# STATE OF OHIO DEPARTMENT OF TRANSPORTATION

## GRE-68-12.65

### BUILDABLE UNIT #3 AND #4

**INTERIM SUBMITTAL  
DATE: 02/17/2025**

DETOUR PLAN  
 LITTLE MIAMI SCENIC TRAIL - BICYCLE

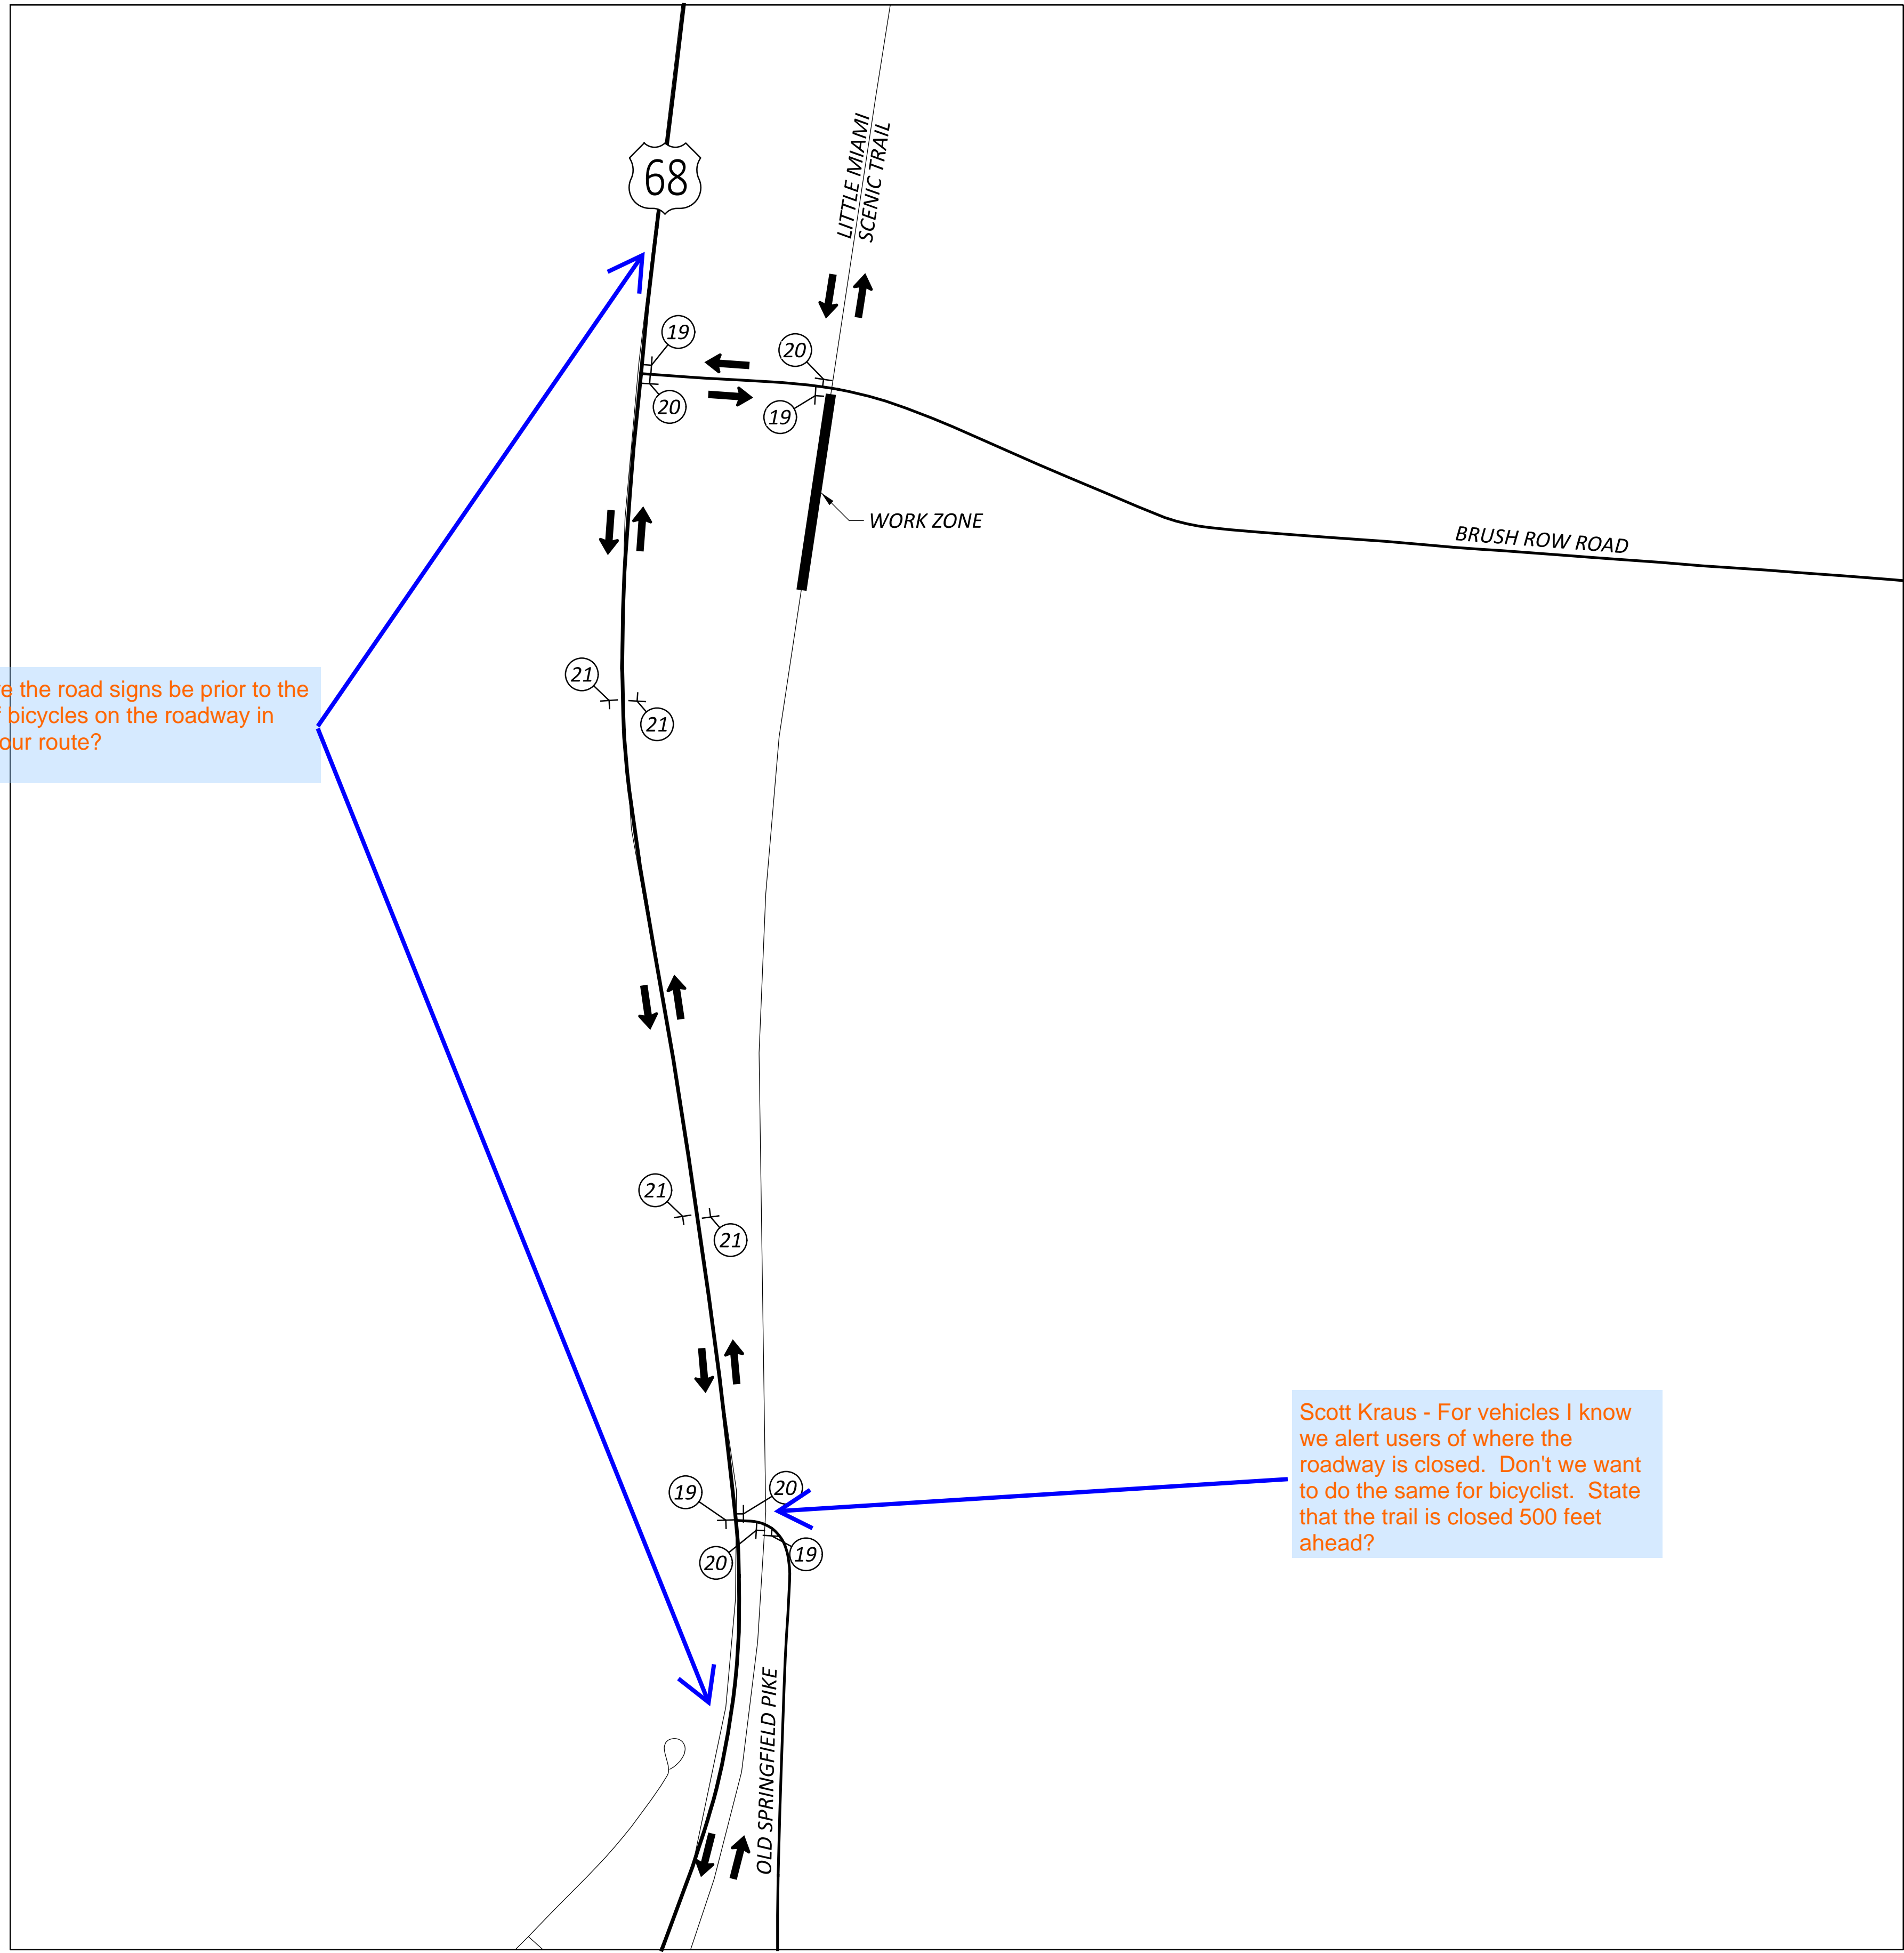
Scott Kraus - Shouldn't the share the road signs be prior to the detour starting to alert drivers of bicycles on the roadway in addition to along the bicycle detour route?

**PLAN AND PROFILE - U.S. 68**  
**STA. 95+50.00 TO STA. 100+50.00**

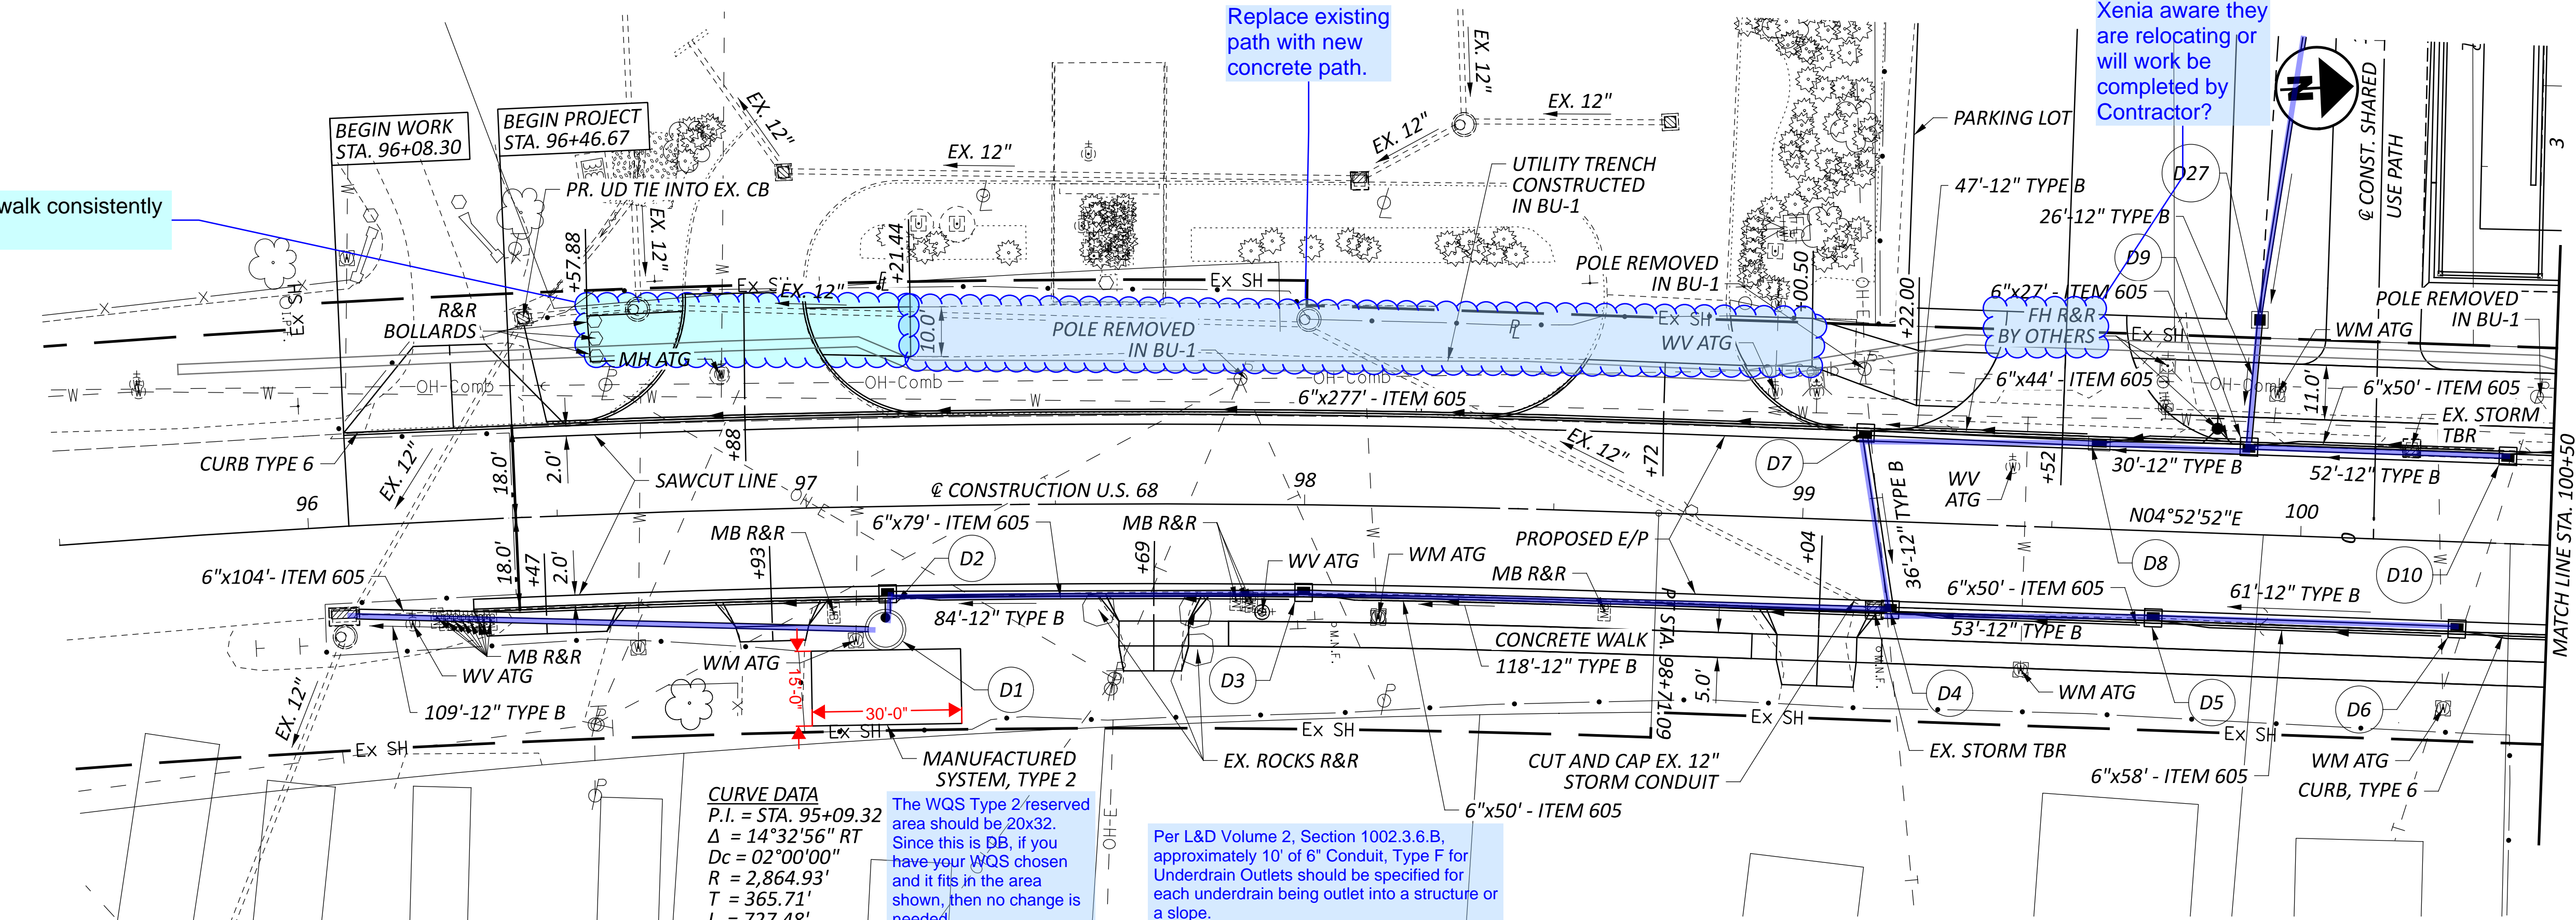
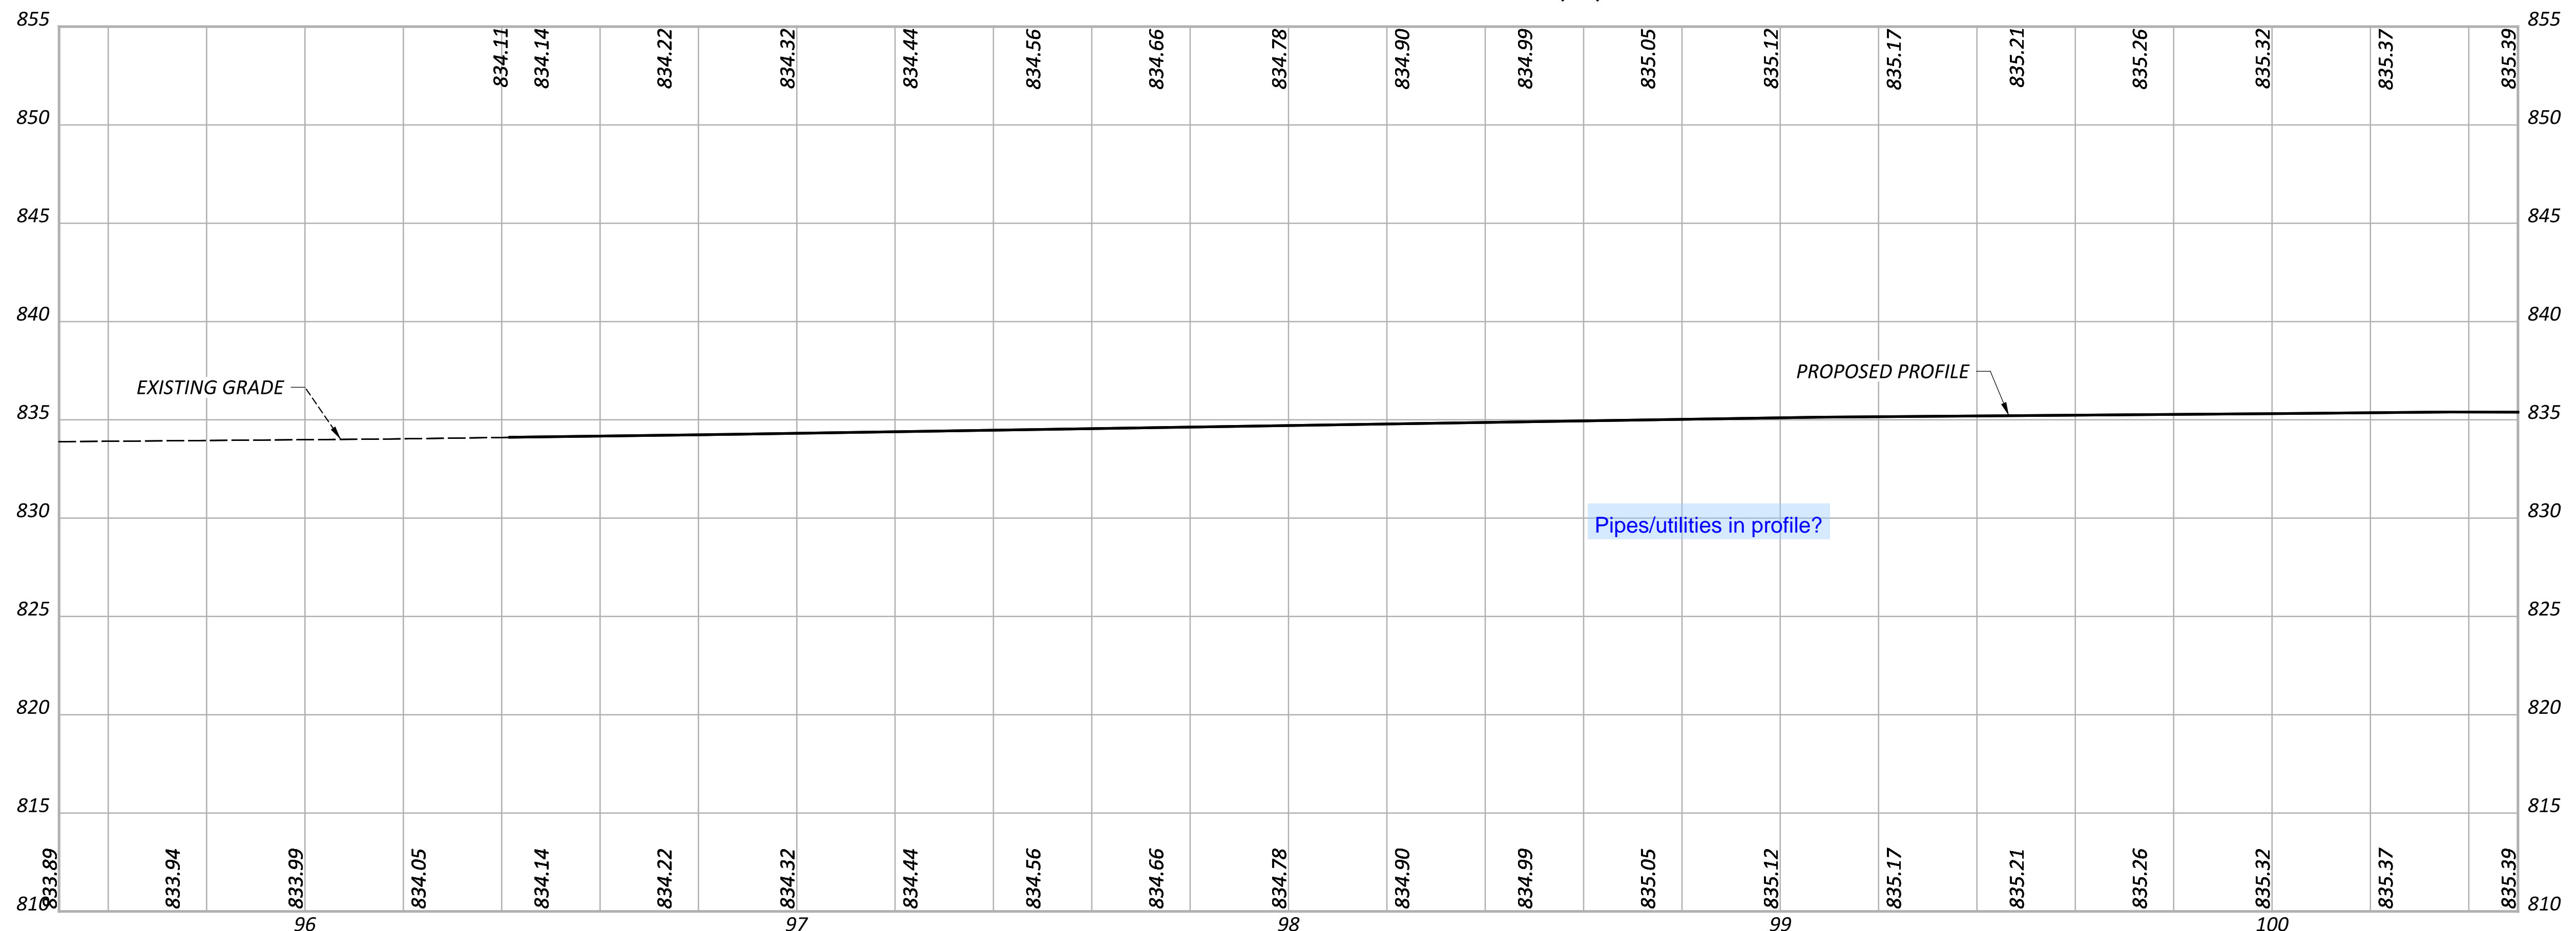
Keep the SUP and sidewalk consistently concrete along US68.

Replace existing path with new concrete path.

Is the City of Xenia aware they are relocating or will work be completed by Contractor?

The WQS Type 2 reserved area should be 20x32. Since this is DB, if you have your WQS chosen and it fits in the area shown, then no change is needed.

Per L&D Volume 2, Section 1002.3.6.B, approximately 10' of 6" Conduit, Type F for Underdrain Outlets should be specified for each underdrain being outlet into a structure or a slope.
